Am186™CC/CH/CU

Microcontrollers Register Set Manual

This document amends the $Am186^{TM}CC/CH/CU$ Microcontrollers Register Set Manual, order #21916B. It consists of these parts:

Figure 5-1 Autobaud Enhancement

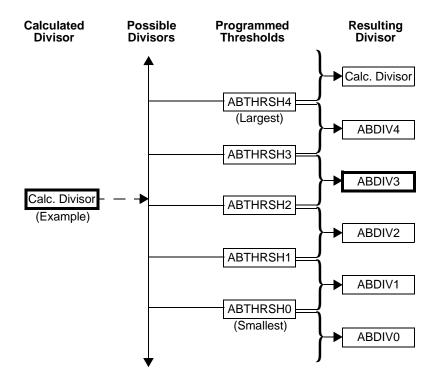
5-24	Figure 5-1 Autobaud Enhancement	[Existing figure]	[Replace with Figure 5-1 on page 12 of this amendment.]	Update and clarify figure.
5-31	Serial Port Status (SPSTAT) register, bit 6 THRE description	[Existing text]	[Add the following note:] Note: Software must verify that the THRE bit is set before writing to the SPTXD register even if the TEMT bit was set before the previous write.

Replace Figure 5-1 on page 5-24 of the manual with the following figure.

- 1. If the calculated divisor is larger than the largest ABTHRSHx bit field value, the resulting divisor is the same as the calculated divisor.
- 2. The ABTHRSH4 or ABTHRSH3 bit field must contain the largest threshold value. If the ABTHRSH4 bit field is not the largest threshold, it must be 0. The remaining ABTHRSHx bit fields must be programmed with successively smaller thresholds for lower-numbered ABTHRSHx bit fields. If all five thresholds are not needed, the lowest-numbered ABTHRSHx bit fields (ABTHRSH0, ABTHRSH1, etc.) can be cleared or left in their default disabled state (00h).
